UNITED STATES PATENT AND TRADEMARK OFFICE

APPLICATION NO.	FILING DATE	FIRST NAMED INVENTOR	ATTORNEY DOCKET NO.	CONFIRMATION NO.
10/538,487	06/08/2005	Edmund W.M. Poh	A1-231 US	2274
23683 7590 03/14/2007 MOLEX INCORPORATED 2222 WELLINGTON COURT LISLE, IL 60532			EXAMINER LE, THANH TAM T	
			ART UNIT	PAPER NUMBER
			2839	
SHORTENED STATUTORY PERIOD OF RESPONSE		MAIL DATE	DELIVERY MODE	
3 MONTHS		03/14/2007	PAPER

Office Action Summary

FIGURE A

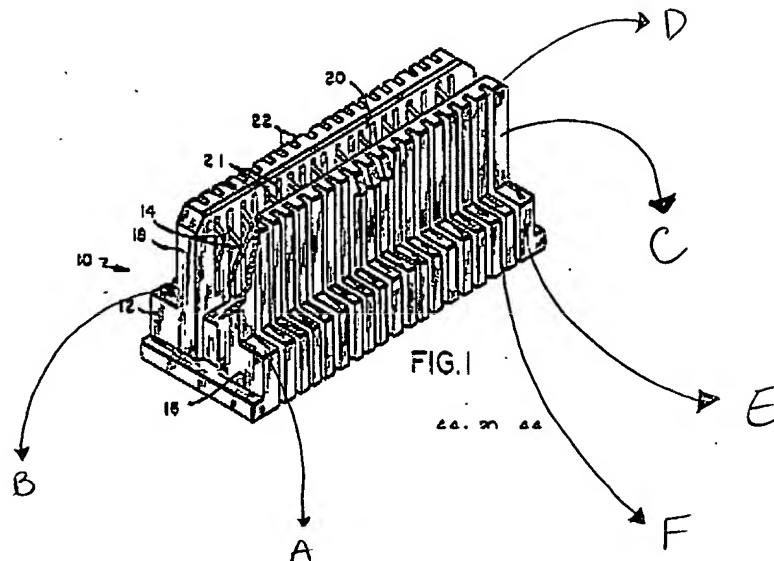
Regarding claims 1, 17 and 19-21, Classon et al., figure 1 shows a connector comprising:

- a housing (10) including a first housing base wall (A) and a second housing base wall (B) connected to the first housing base wall and spaced therefrom, the first and the second housing base walls each having an inner side and an outer side, opposite side, the inner side of the first housing base wall facing the inner side of the second housing base wall, a plurality of ribs (C)

- extending from the first and second housing base walls and spaced apart from each other such that a slot (21) is defined between adjacent ribs, each rib including a first rib portion extending from the first housing base wall in a first direction and a first rib portion extending from the second housing base wall in the first direction such that each slot has a first slot portion (D) which is open to the outer sides of the first and second housing base walls, and a second rib portion (E) extending from the first housing base wall in a second, opposite direction, and a second rib portion extending from the second housing base wall in the second direction such that the each slot has a second slot portion (F); and

- at least one terminal (14) positioned within the each slot and connected to the housing such that a surface area of the at least one terminal is exposed to the environment and air can flow over the surface area to dissipate heat from the at least one terminal.

Regarding claim 2, the at least one terminal is positioned within a respective first slot portion and second slot portion.

Regarding claim 18, the first direction is a direction away from the circuit substrate.
